UNITED STATES PATENT AND TRADEMARK OFFICE

10/743,854

Office Action Summary	Application No.	Applicant(s)	
	10/743,854	MATSUSHITA ET AL.	
	Examiner	Art Unit	
	Burton S. Mullins	2834

DETAILED ACTION

Fig. 2.

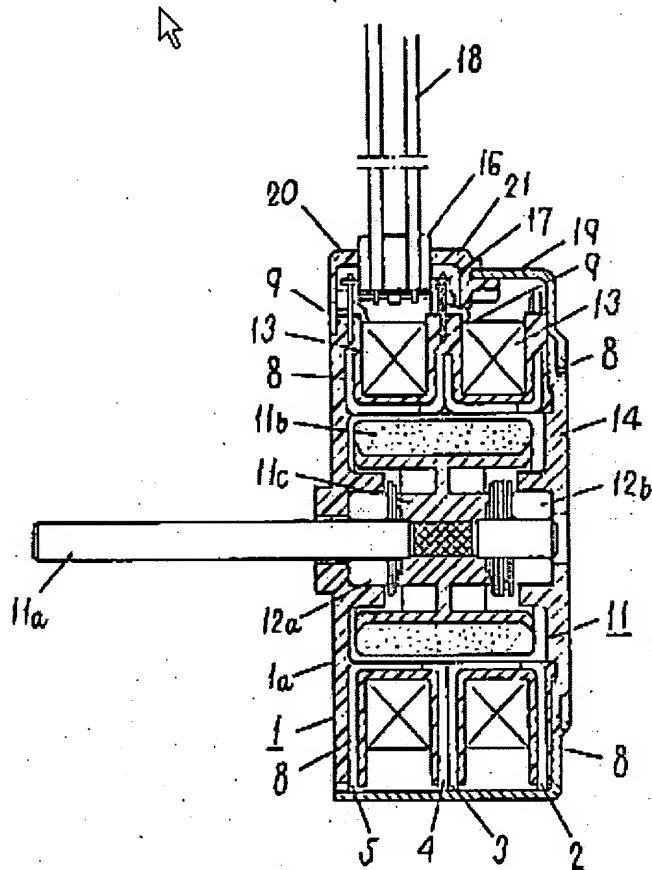
5. Claims 2, 7 and 11-12 are rejected under 35 U.S.C. 103(a) as being unpatentable over Akiba et al. (US 4,714,850) in view of Tanaka (US 4,015,154), further in view of Horberg (US 3,001,839). With reference to the marked Figure 2 below, Akiba teaches a stepping motor comprising: a rotor 11 including a shaft 11a and a magnet 11b surrounding a portion of the shaft (Fig.2); a stator 1 surrounding the magnet of the rotor with a gap therebetween (not numbered, Fig.2), and adapted to generate a magnetic field thereby causing the rotor to rotate around an axis of the shaft (inherent); a rotor sleeve 11c having a cylindrical portion (not numbered, Fig.2) and a flange (not numbered, Fig.2) provided at one end of the cylindrical portion, the rotor sleeve 11c being provided between the magnet 11b and the shaft 11a so as to fixedly hold the magnet and the shaft together (Fig.2); a boss (holding part) 1a having a circular shape with a center hole (not numbered; Fig.2) for allowing the shaft 11a to rotatably pass therethrough and being formed (by monolithic resin molding) with the stator 1 (c.3, lines 37-51) so as to oppose the flange of the rotor sleeve (Fig.2); and a bearing 12a rotatably disposed between the boss and flange of the rotor sleeve (Fig.2).

Akiba does not teach: 1) ball bearings, per se, for the bearing 12a; or 2) an inner surface of the boss beveled to form a conical configuration with a diameter increasing from the center hole of the boss.⁷
